SUBJECT: Inner Harbor Navigation Canal Lake Borgne Barrier Wall-Waiver for Deflections of the Proposed Floodwall

SUBJECT: Inner Harbor Navigation Canal Lake Borgne Barrier Wall –Waiver for Deflections of the Proposed Floodwall

Summary and Conclusion of the Lake Borgne Barrier Floodwall Sensitivity Analysis

Figure 3. Relative (to pile tip) horizontal deflections of the 66-inch vertical pile for different strength reduction factors (SRF).

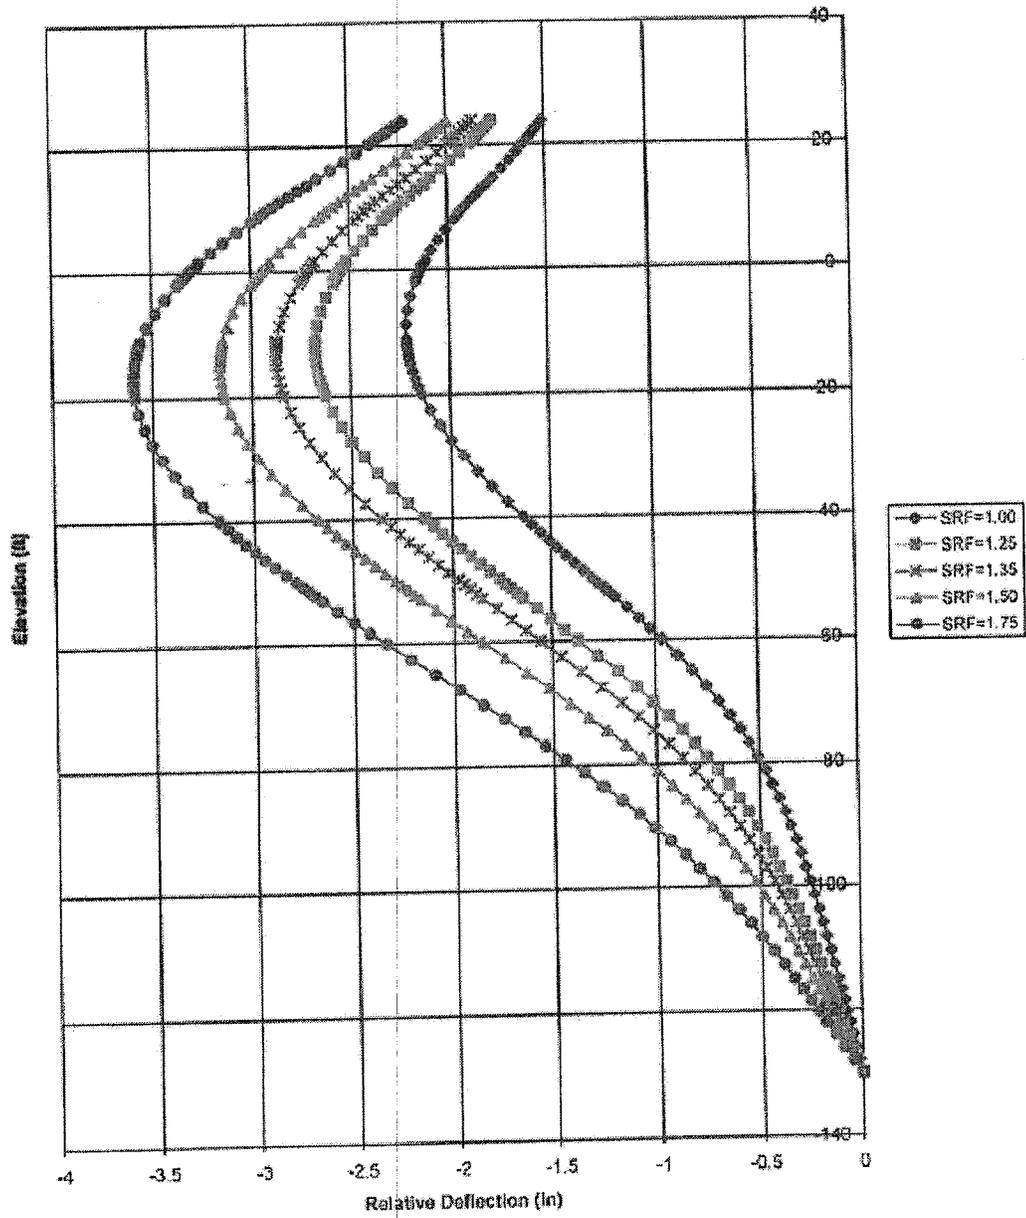
The results of the analysis indicate soil strength reduction factors of over 1.75 can be achieved while still providing adequate safety factors and without soil-structure instability of the floodwall system. The strength reduction factor of 1.75 is equivalent to a reduced strength of 1.0/1.75 (or 57% of the base case soil strengths). The maximum lateral deflections of the 66-in vertical pile relative to tip went from approximately 2½ inches (at EL -20 ft) for the base case (using design strengths) to about 3½ inches in the reduced strength case. Figure 3 shows the range of deflections (relative to the tip of the pile) corresponding to the strength reduction factor used. Figure 4 shows how the maximum horizontal deflection (at around elevation -10 ft to -20 ft) changes with changing strength reduction factor.

Figure 5. Variation in bending moment in the 66-inch vertical pile. The red line represents the analysis with no strength reduction, the blue line the case using a strength reduction factor of 1.75.

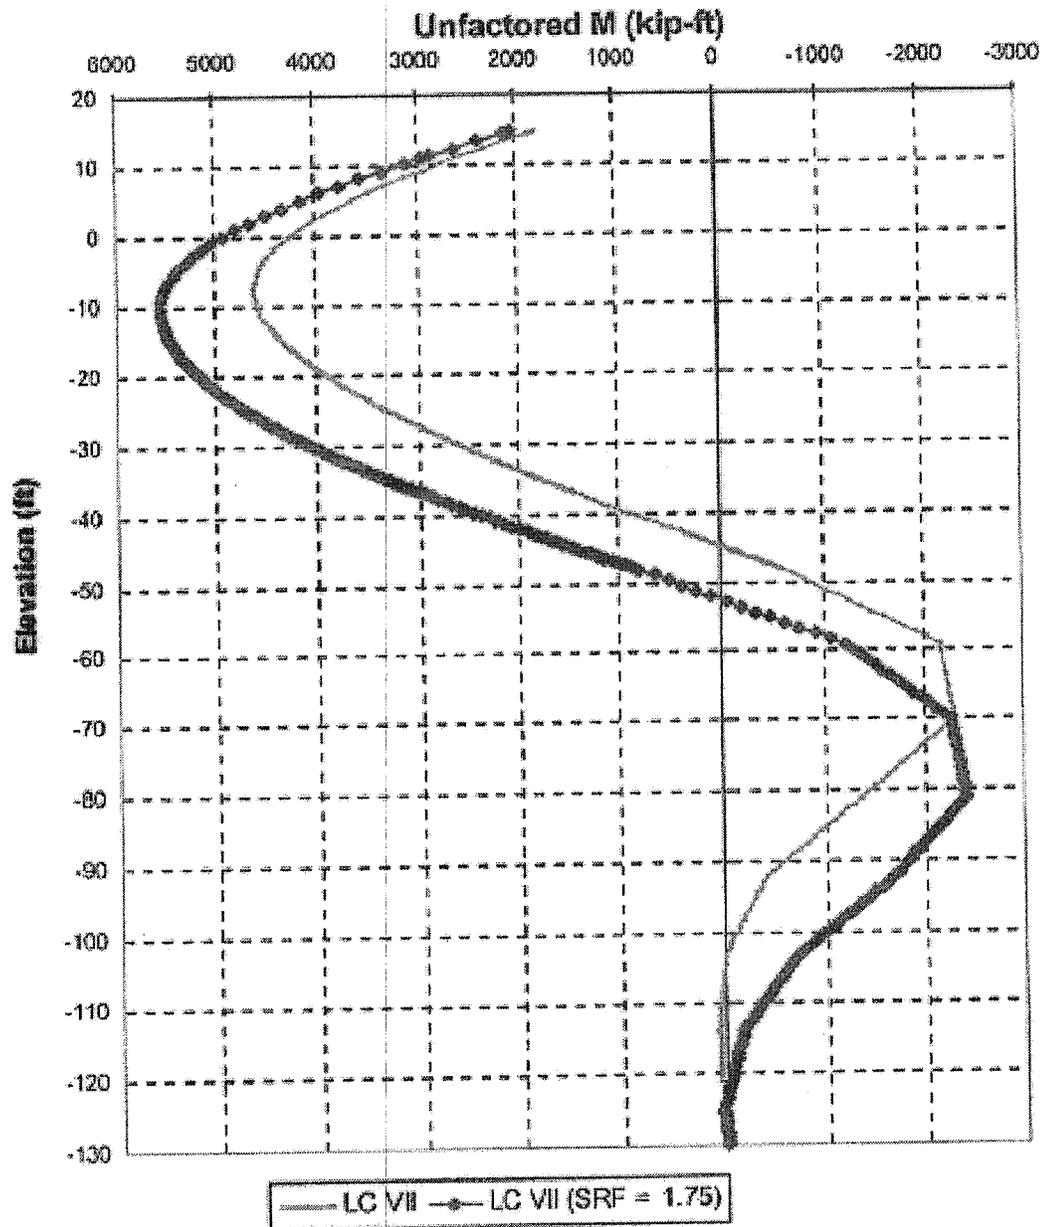
The results of the SAP2000 analysis showed the stress-strain behavior of the structural components remained elastic and within acceptable limits. The change in bending moment of the 66-inch vertical pile from the base soil strength case to the reduced soil strength case is depicted in Figure 5. As the figure shows, the maximum bending moment increased approximately 20% over the base case. Numerical results of the SAP2000 analysis are provided in Table 1.
